1st Further Information

**Proposed Temporary Warehouse (Excluding Dangerous Goods Godown) with Ancillary Facilities
for a Period of 3 Years and Associated Filling of Land in “Agriculture” Zone,
Lot 154 RP (Part) in D.D. 106 and Adjoining Government Land,
Kam Tin, Yuen Long, New Territories**

(S.16 Planning Application No. A/YL-KTS/1045)

Responses-to-Comments

DWG. TITLE TREE SURVEY PLAN	
DWG. NO. TSP01	VER. 0

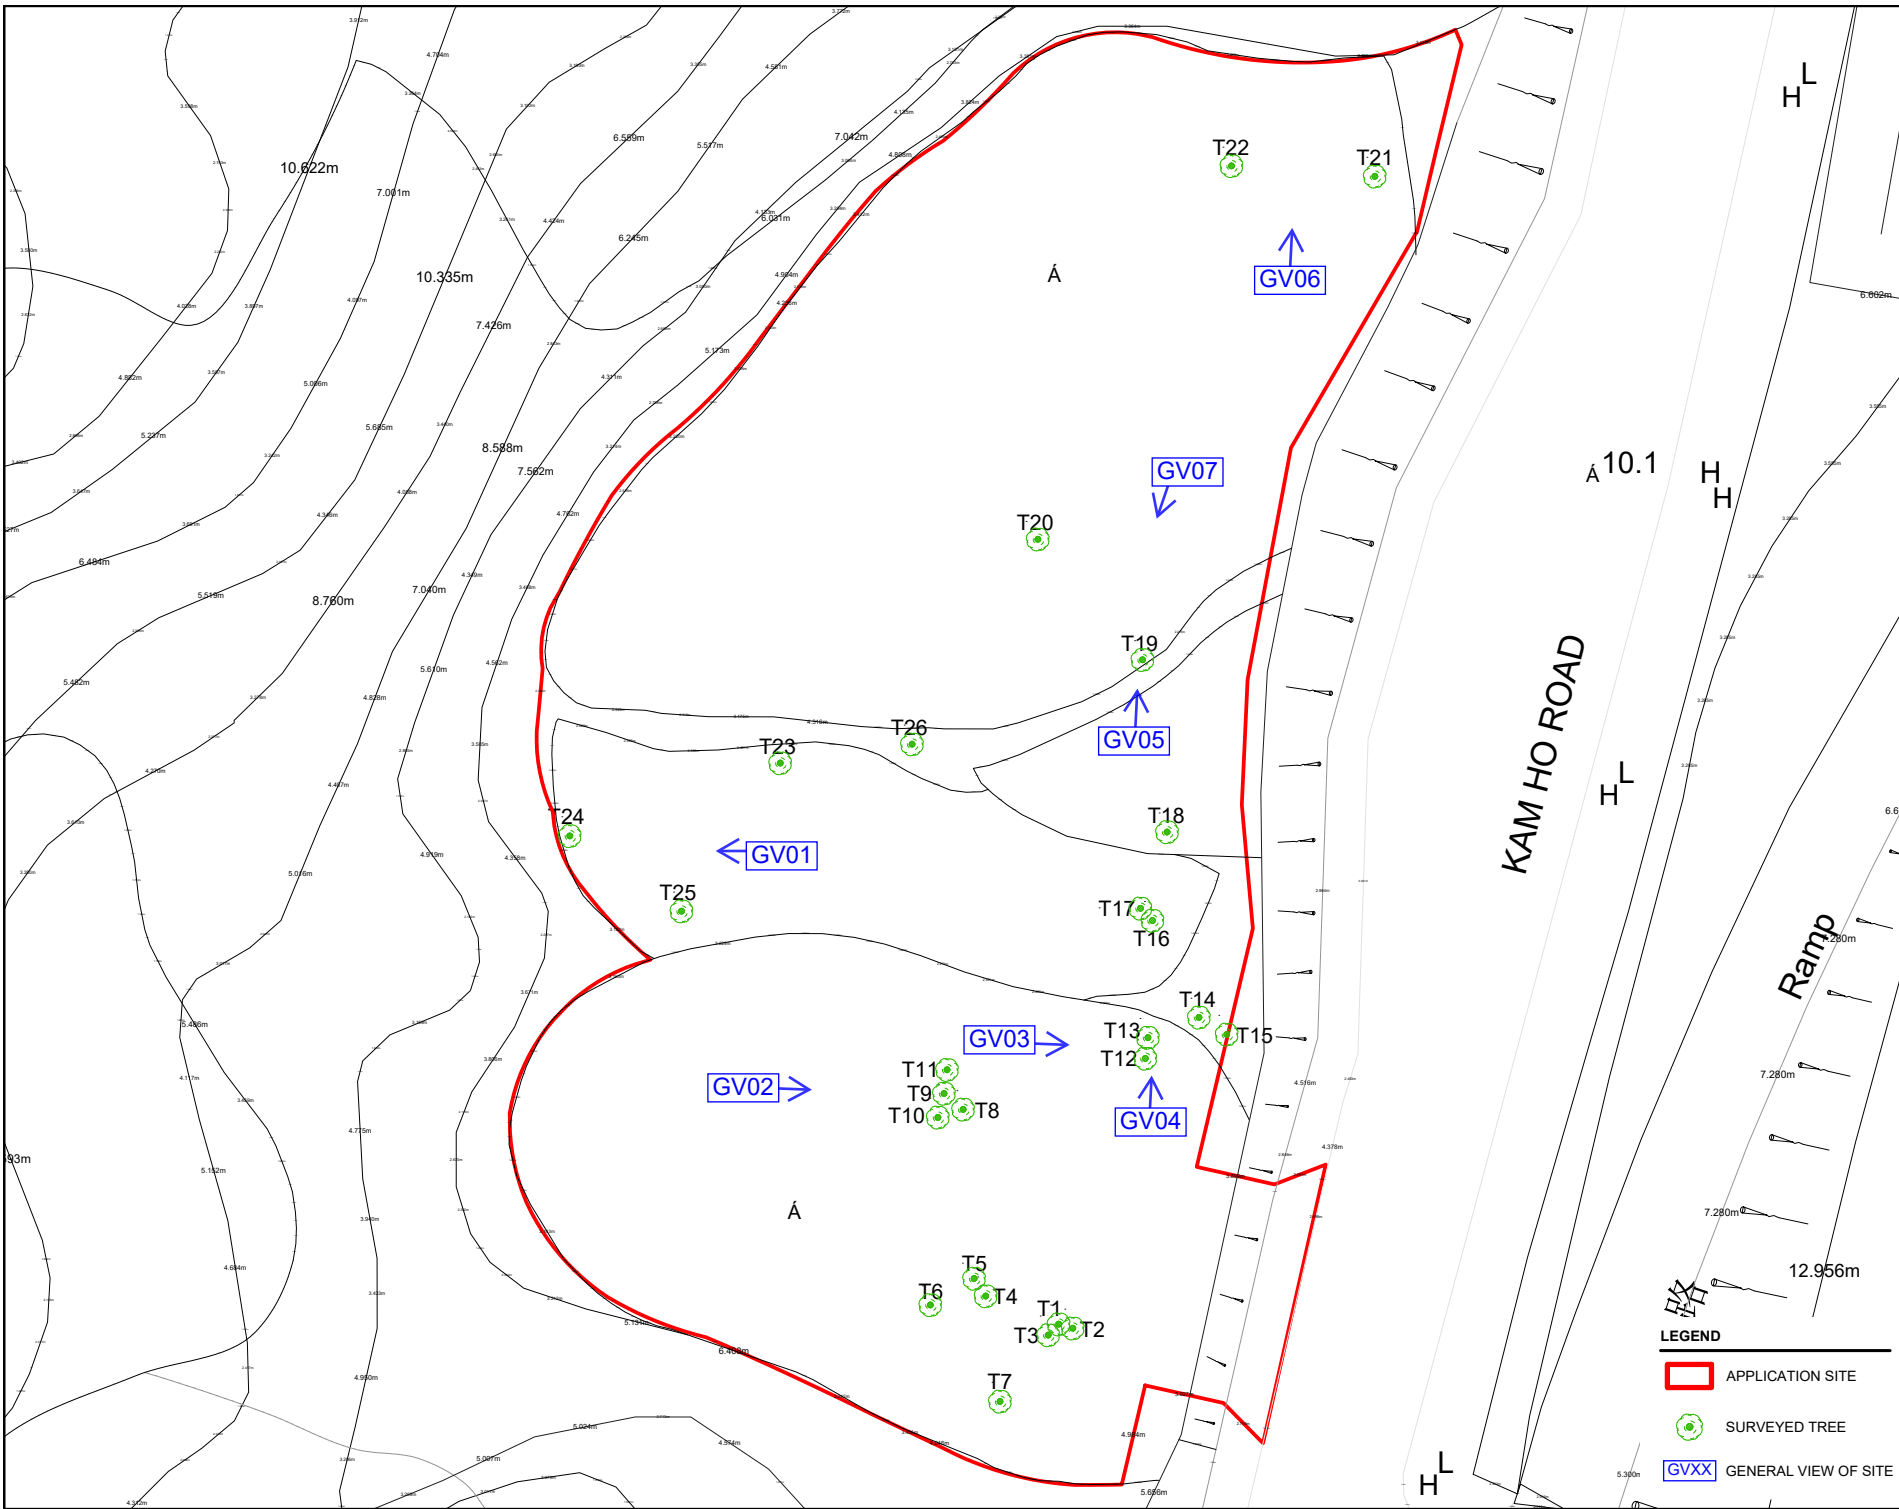
Departmental Comments		Applicant’s Responses
1. Comments of the Chief Town Planner/Urban Design and Landscape, Planning Department (CTP/UD&L, PlanD)		
(a)	No tree information and mitigation measure(s) are provided in the application.	<p>The site inspection conducted on 14.1.2025 identified 26 existing trees within the Site. All trees identified thereon are of common species, whilst 20 of them are of invasive alien species i.e. <i>Leucaena leucocephala</i>. The tree survey report is enclosed at Annex 1a.</p> <p>The existing trees are proposed to be felled as they are in conflict with the proposed development scheme. Given that <i>Leucaena leucocephala</i> is an invasive alien species, the removal of 20 of them are not to be compensated. In order to mitigate the potential landscape impact that would have arisen from the proposed development, the applicant proposes to plant 6 new trees of local species, i.e. <i>Bauhinia x blakeana</i>, at the Site on a 1:1 ratio, with a view to compensating for the existing trees to be felled.</p> <p>In view of the provision of new trees, the extent of the proposed filling of land has been revised. The area of the proposed filling of land is reduced from 2,124 m² to 2,072 m² (about), i.e. 97.6% (about) of the site area.</p> <p>The landscape plan is enclosed at Annex 1b. The revised plan showing filling of land at the Site, and the revised pages of Form No. S16-III & Planning Statement are enclosed at Annex 2.</p>

Departmental Comments		Applicant's Responses
2. Comments of the Director of Agriculture, Fisheries and Conservation (DAFC)		
(a)	It is noted from the aerial photo that the subject site is vegetated, yet it is noted from item e(iii) in part 6 of the application form that there will be no tree felling, please ask the applicant to clarify whether tree will be felled for the proposed use.	The tree survey report is enclosed at Annex 1a . For details, please refer to the above applicant's response to CTP/UD&L, PlanD.

At the time of inspection on 14th January 2025, **26 nos.** trees were found within the Site. **No** dead tree was recorded in the surveyed area. Location of individual tree refers to Appendix I.
